UNITED STATES PATENT AND TRADEMARK OFFICE

| APPLICATION NO. | FILING DATE | FIRST NAMED INVENTOR | ATTORNEY DOCKET NO. | CONFIRMATION NO. |
|---|-------------|----------------------|---------------------|------------------|
| 10/802,668 | 03/17/2004 | Terunao Hanaoka | 81754.0118 | 2671 |

| Office Action Summary | Application No. 10/802,668 | Applicant(s) HANAOKA, TERUNAO | |

DETAILED ACTION

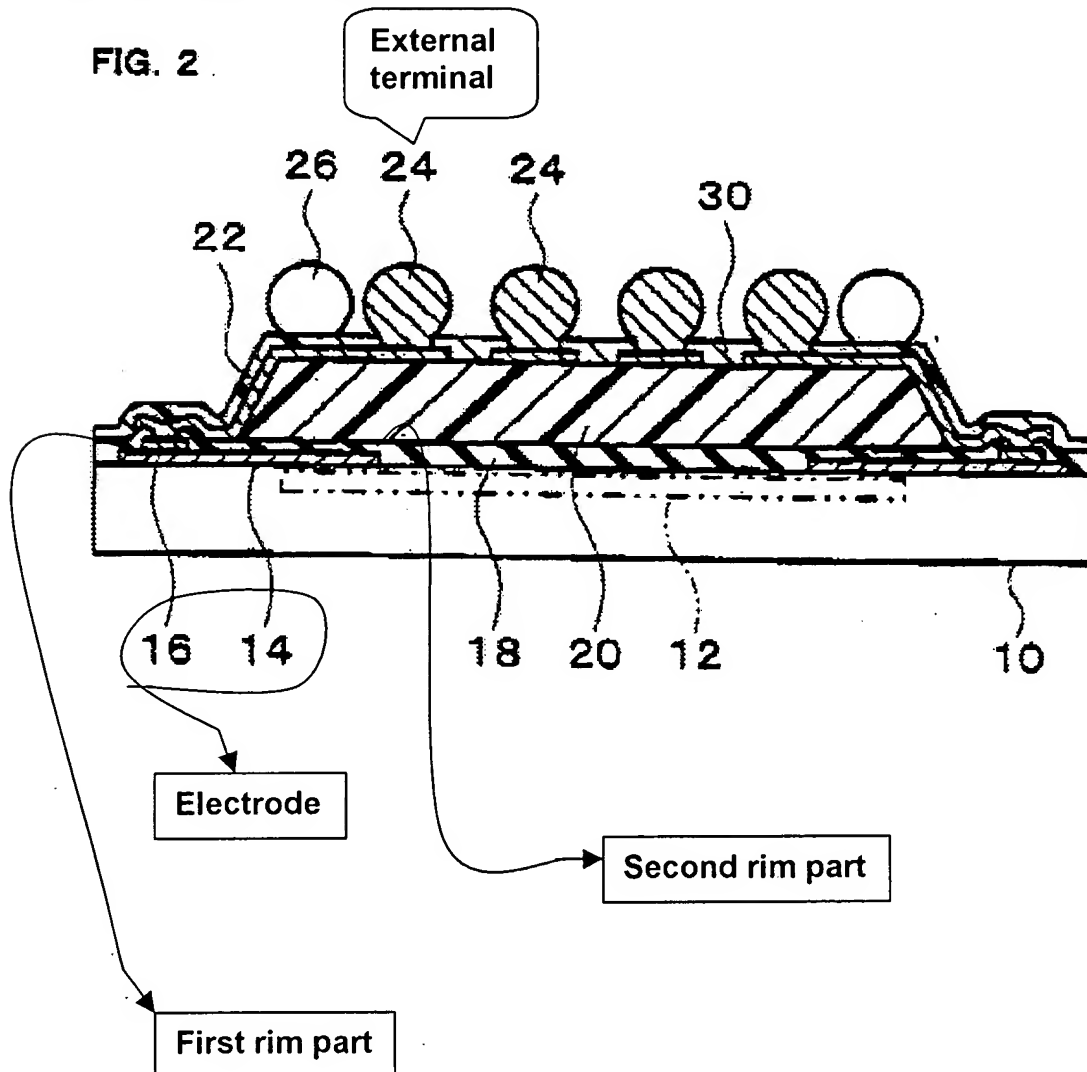
Regarding claim 1, Yamaguchi (Fig. 2) discloses a semiconductor device, comprising:

wherein the electrode (14,16) has a first rim part facing a periphery of the semiconductor substrate 10 and a second rim part facing a center region of the semiconductor substrate 10 (see Fig. 2 labeled by the examiner below), and

wherein the resin layer 20 is formed so as to overlap the second rim part, leaving out an area from the periphery of the semiconductor substrate 10 to the first rim part of the electrode (14,16).

Regarding claim 2, Yamaguchi (Fig. 2) discloses that a passivation film 18 having an opening which exposes a part of the electrode (14,16) is formed on the side of the semiconductor substrate 10 where the electrode is formed, and the resin layer 20 is formed on the passivation film 18 (paragraph [0079]).

Regarding claim 4, Yamaguchi (Fig. 2) discloses that a center of the opening is positioned so as to deviate from a center of the electrode (14,16) towards the periphery of the semiconductor substrate 10.

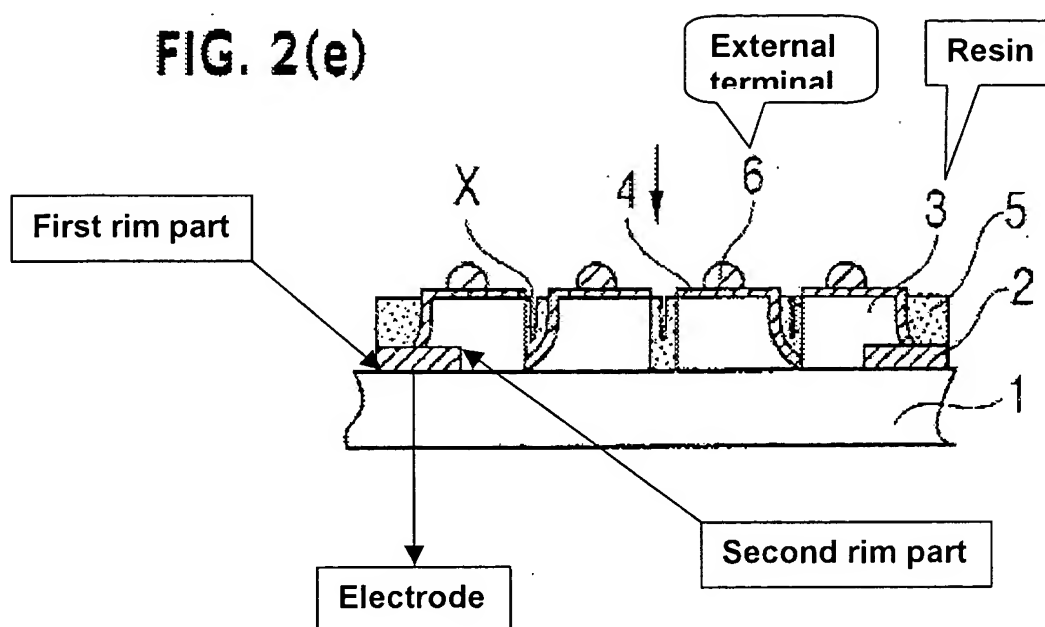
Regarding claim 1, Nagai (Figs. 2a-2f) discloses a semiconductor device, comprising:

wherein the electrode 2 has a first rim part facing a periphery of the semiconductor substrate 1 and a second rim part facing a center region of the semiconductor substrate (see Fig. 2e labeled by the examiner below), and

wherein the resin layer 3 is formed so as to overlap the second rim part, leaving out an area from the periphery of the semiconductor substrate to the first rim part of the electrode 2 (see Fig. 2e and Fig. 4).

wherein the electrode 2 has a first rim part facing a periphery of the means for accommodating and a second rim part facing a center region of the means for accommodating (see Fig. 2e); and

wherein the resin layer 3 is formed so as to overlap the second rim part, leaving out an area from the periphery of the means for accommodating to the first rim part of the electrode 2 (Fig. 2e and Fig. 4).
